SOIL SITE INVESTIGATION  
AT  
MAGNETAWAN RIVER/HVY 56  
KEARNEY

March 9, 1960.  
FOUNDATION REPORT - by  
E.M. Peto Associates, Ltd.

Re: Magnetawan River Bridge,  
Kearney, Ont. - Hwy. 518,  
W.P. 223-59 - District 11.

**MAGNETAWAN RIVER BRIDGE - HIGHWAY 518**

SOIL TESTS MADE IN S.W. QUARTER SECTION 1116-09

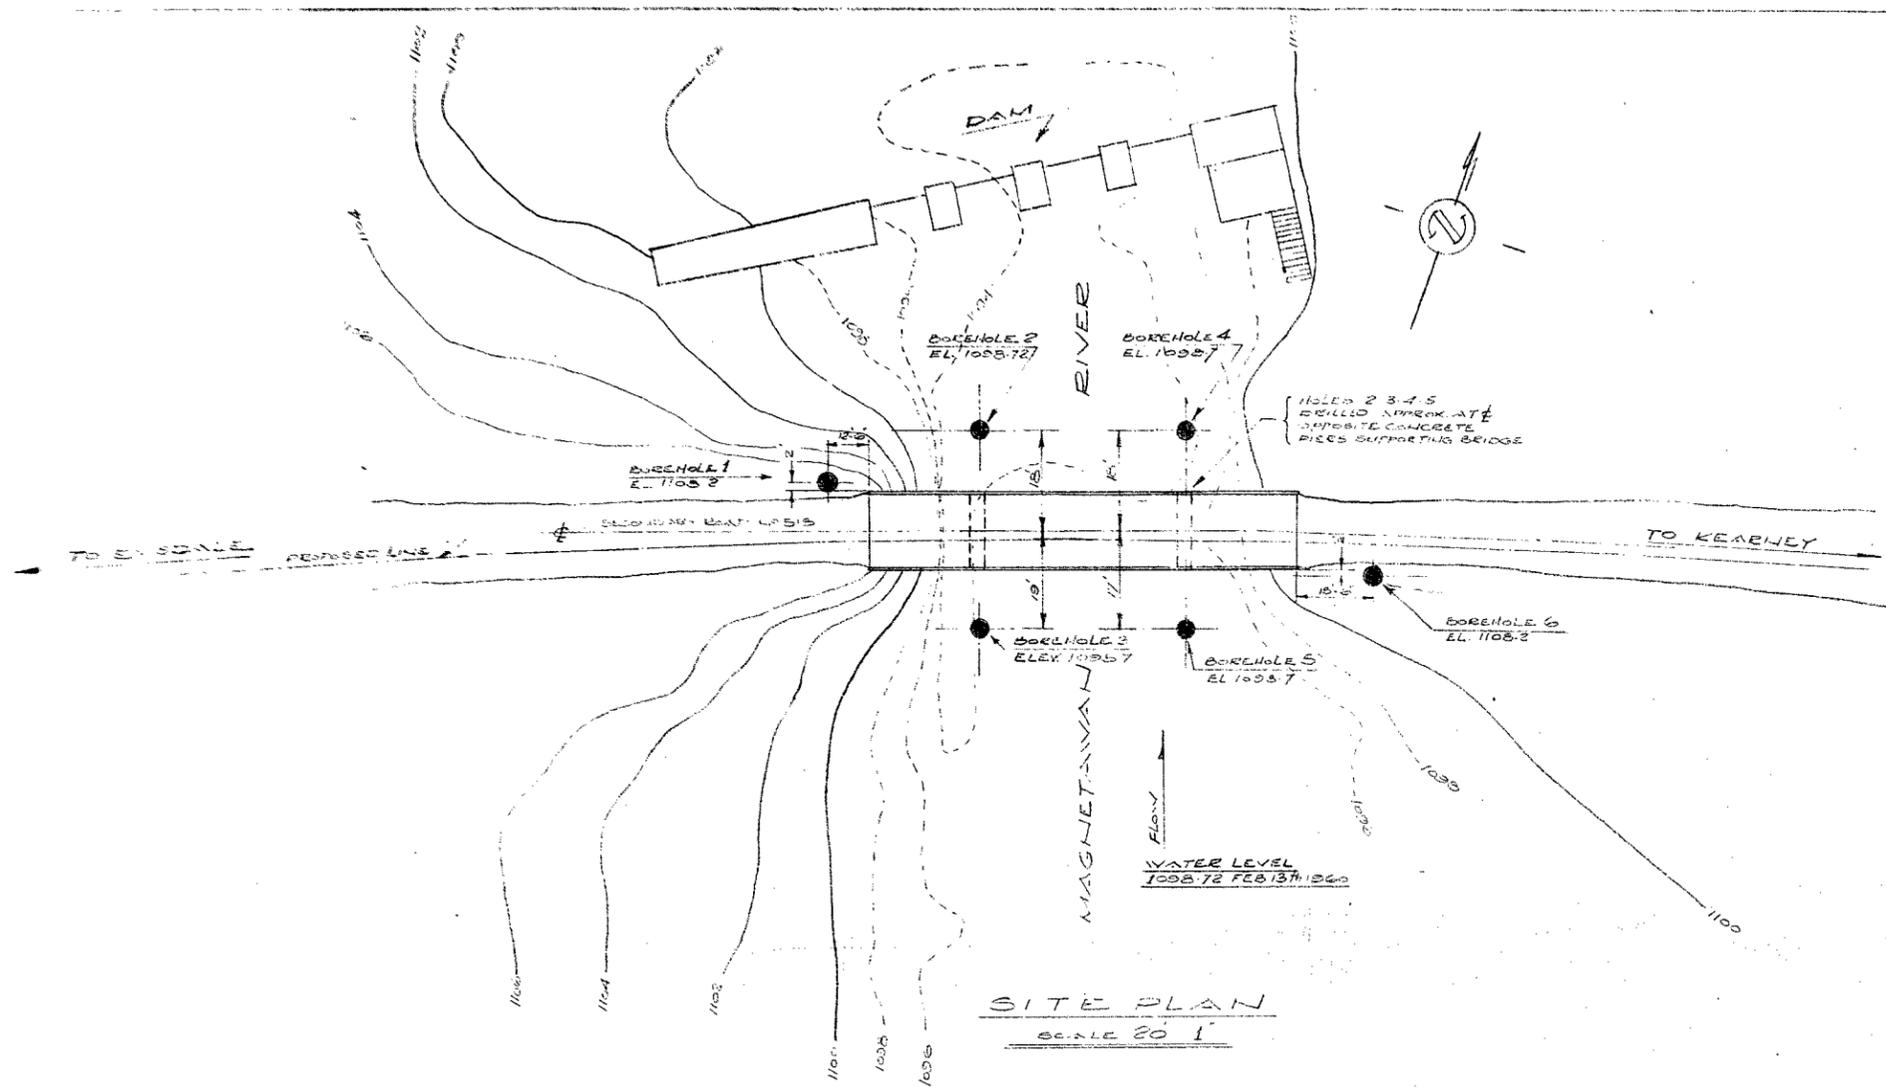
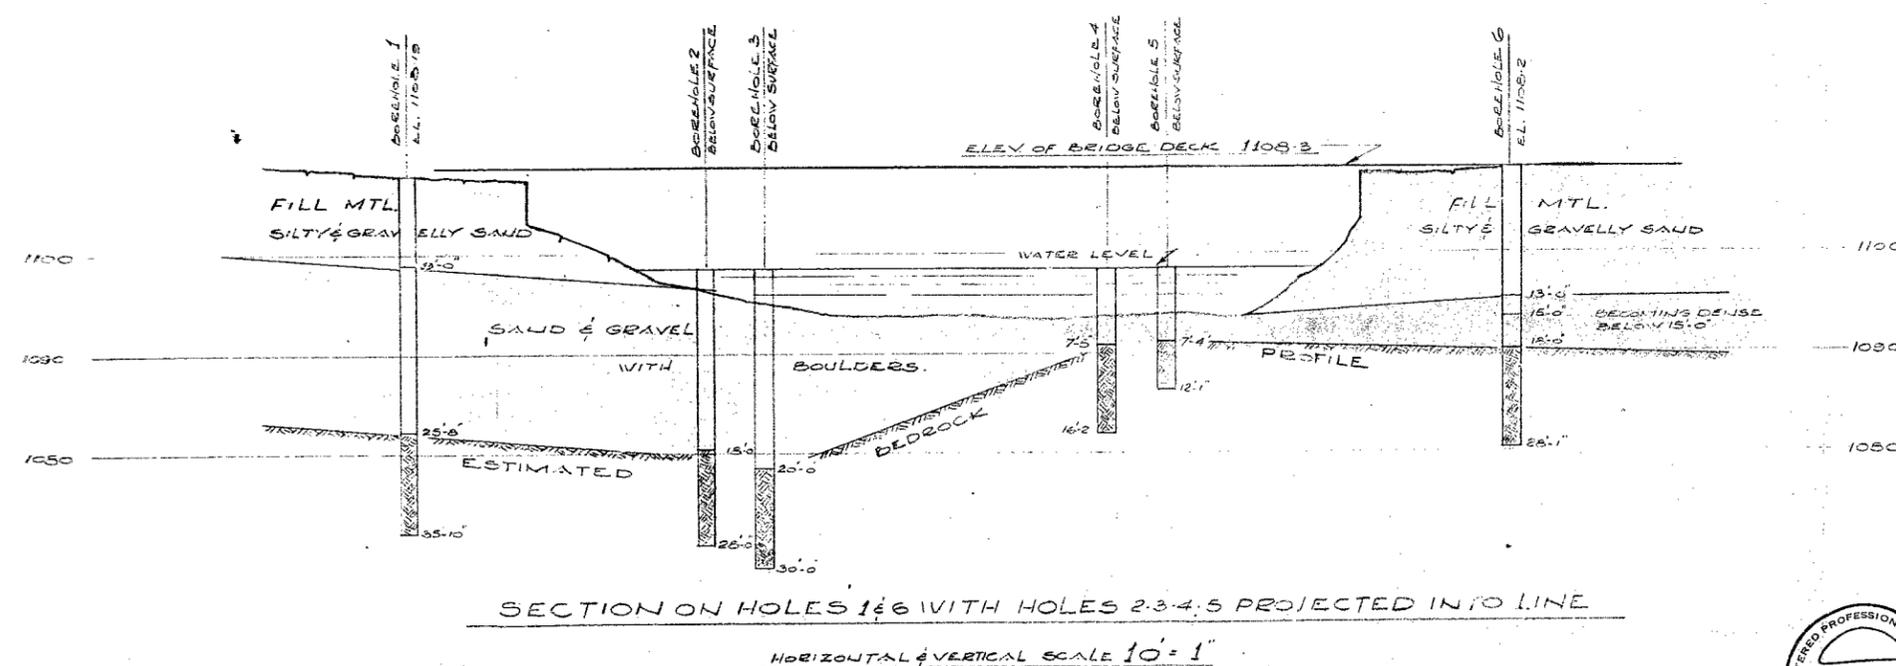
As proposed by the Consultant, the East pier and abutment may be founded on bedrock at approx. elevation 1090.0'. These footings would be approx. 9 feet below water level. Dewatering of this excavation will be difficult and a tremie concrete may best be specified. If sheet piling is called for, heavy sections should be used since difficult driving is anticipated. Large boulders should be removed from the surface before attempting to drive the sheet piling. The depth of penetration of sheet piling, as seen from boreholes 4 and 5, will be small. If a braced sheet pile cofferdam is attempted, and dewatering of this cofferdam is suggested, a tremie concrete seal at the bottom, will be required to prevent a large influx of water from the irregular bedrock surface.

At the West abutment and pier, steel 'H' piles, driven to bedrock at approx. elevation 1082', may be used. If it is desired to use spread footings for the West pier and abutment, these footings may be designed for a bearing pressure of 3 T/ft.<sup>2</sup> at elevation 1090' in the vicinity of Boreholes 2 and 3, and elevation 1099' in the vicinity of Borehole 1. Steel sheet piles will probably meet refusal to driving at from 4 to 5 feet from the bedrock surface, while steel 'H' piles should penetrate to the surface of the bedrock. A 14" steel 'H' pile at 73#/ft. may be designed to carry a load of 50 tons.
